UNITED STATES PATENT AND TRADEMARK OFFICE

Office Action Summary

10/679,552

WAFZIG, JURGEN

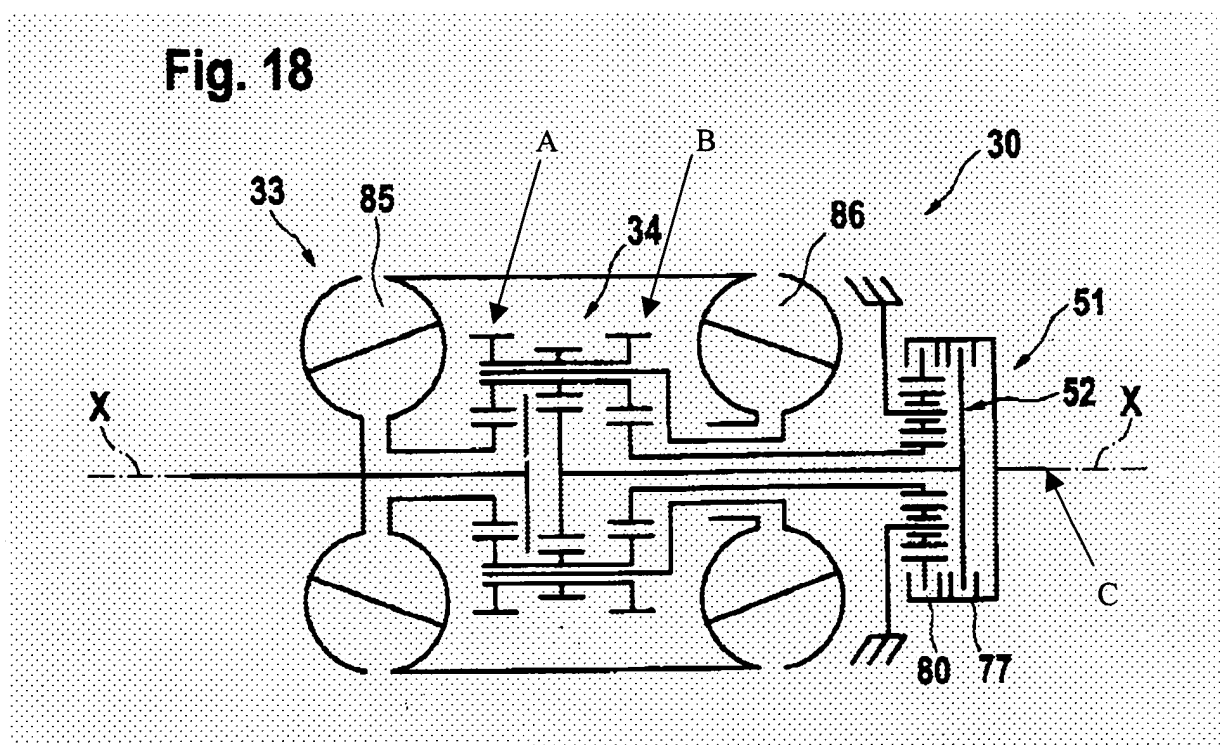
Geiberger et al teach a split performance power train (see Fig. 18) comprising:

wherein a first planetary gear set (A) (see the Fig. below) and a third planetary gear set (B or 52) are planned, whereby the friction wheel variable speed transmission (33), the first planetary gear set (A), a second planetary gear set (52 or B) and the third planetary gear set (B or 52) are coaxial and arranged consecutively in the direction of the power flow.

Regarding claim 9, wherein the transmitted power in the friction wheel variable speed transmission (33) over the first planetary gear set (A) is transmitted coaxially through the friction wheel variable speed (33) to the second planetary gear set (52).

Regarding claim 10, wherein the third planetary gear set (52) is arranged at a side of an output (C).

Regarding claim 11, wherein the first planetary gear set (A) is arranged between paired disks of the friction wheel variable speed transmission (33).
